ARTHUR ALTEMOSE ARCHITECTS

RE: WINDSOR BLDG #2

Date: Thursday, February 17, 2005

The layout that was sent to you yesterday has been revised.

B

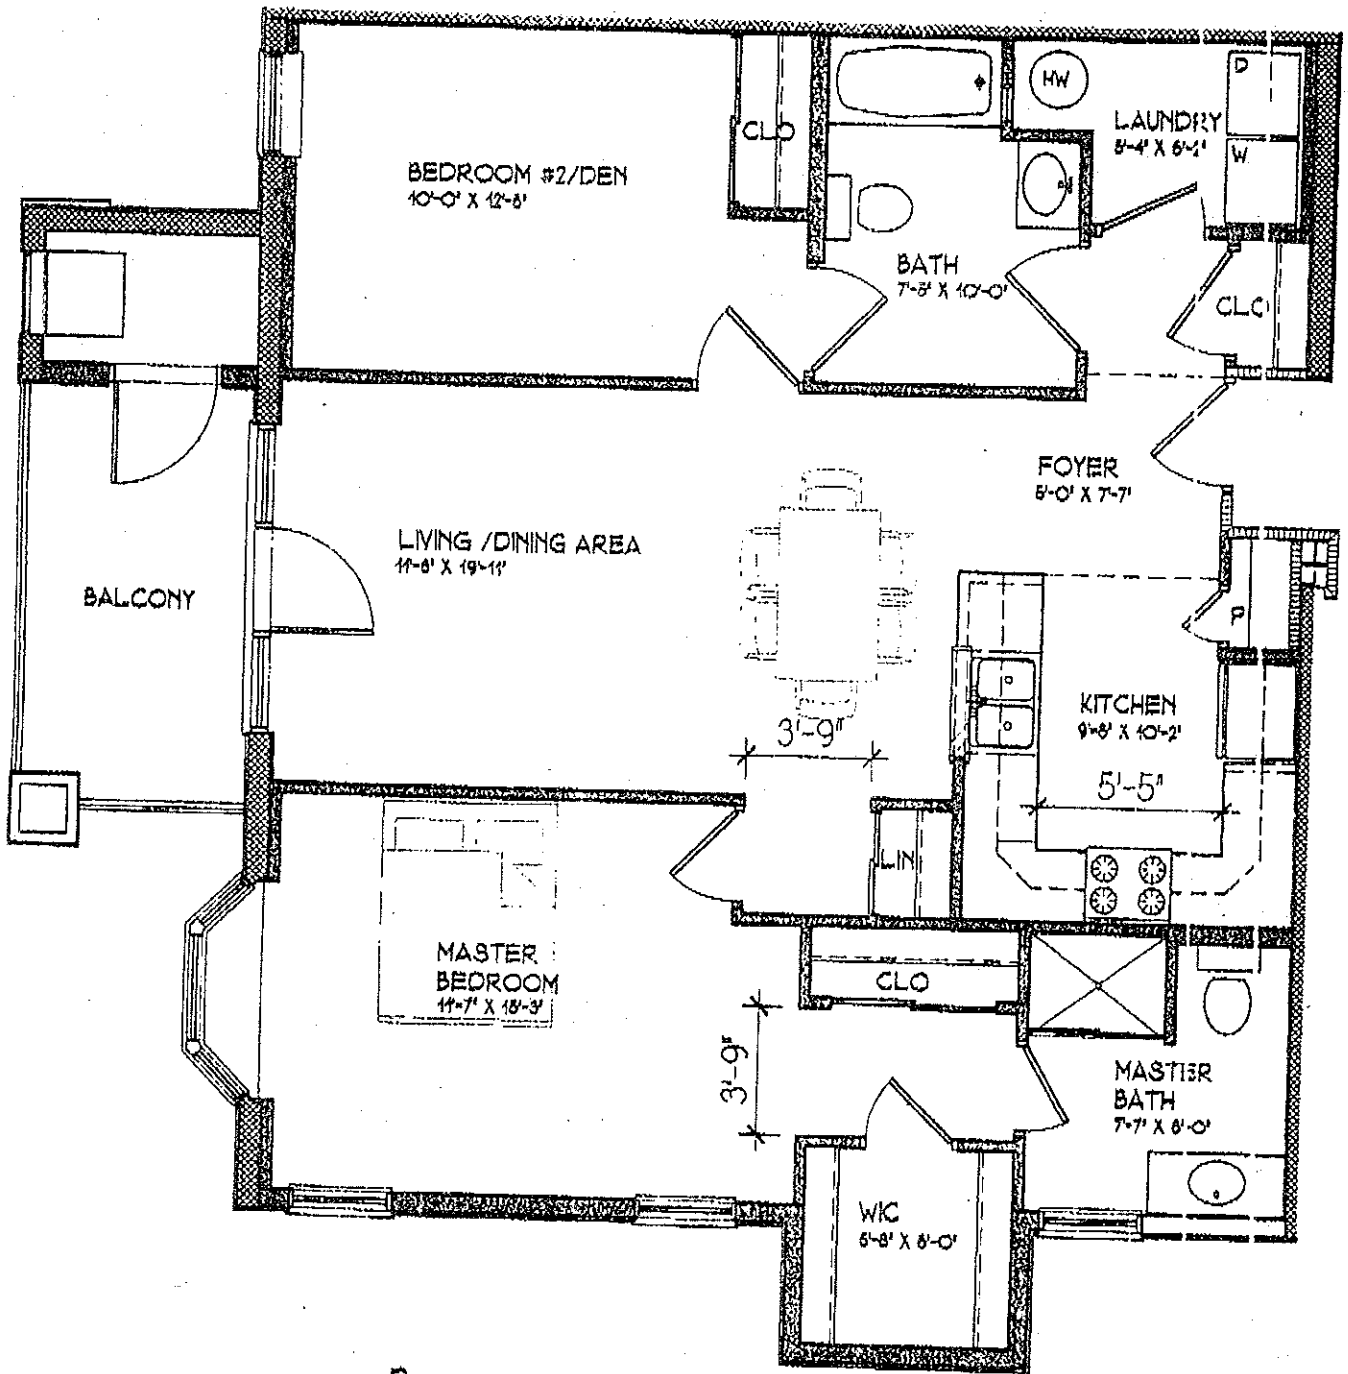
1. Kitchen opt bigger, more space bet counters.
2. Master Bedroom is now 11'-7" x 15'-3".
3. Master Bath is 7'-7" x 8'-0"
4. Walk-in closet is 5'-8" x 6'-0"
5. Total area: 1227 s.f.

Attached herein is the revised layout for end-unit of Windsor Bldg. #2, for your perusa and comment.
